Executive Director's Recommendation

Commission Meeting: November 1, 2012

PROJECT THE SMITHSONIAN INSTITUTION NATIONAL MUSEUM OF AFRICAN AMERICAN HISTORY AND CULTURE SMITHSONIAN INSTITUTION Constitution Avenue and Madison Drive between 14th and 15th Streets, NW Washington, DC	NCPC FILE NUMBER 6331 NCPC MAP FILE NUMBER 1.42(38.00)42654 APPLICANT'S REQUEST Final approval of site and building plans
SUBMITTED BY Smithsonian Institution	PROPOSED ACTION Approve with conditions
REVIEW AUTHORITY PL 108-184 per 40 U.S.C. § 8722(b)(1) and (d)	ACTION ITEM TYPE Staff Presentation

Figure 9: Corona Panel Support System

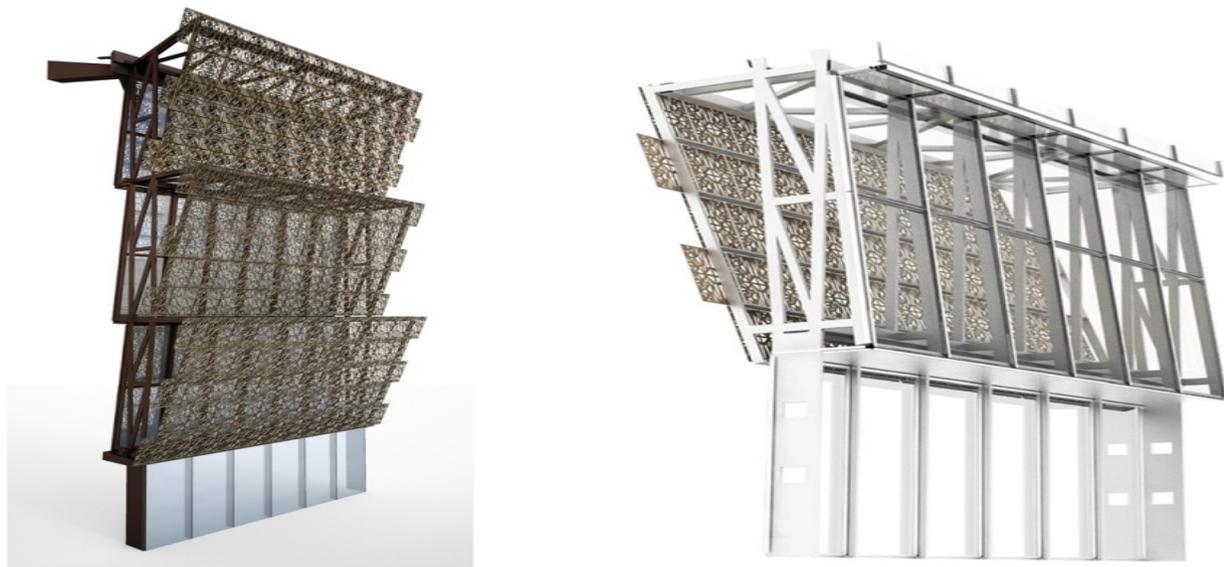
Notes: that since the treatment of the corona has not been finalized and is an important element of the design, further analysis needs to be undertaken to determine the final finish and color of the corona panels. Therefore, the Commission **delegates** the final approval of the corona finish to the Executive Director upon staff evaluation of the full scale corona mock-up.

The corona panel support system has been modified from the suspended cable system to vertical trusses. Budget was the major driver for the change in the system. Facilities maintenance also contributed to this decision.
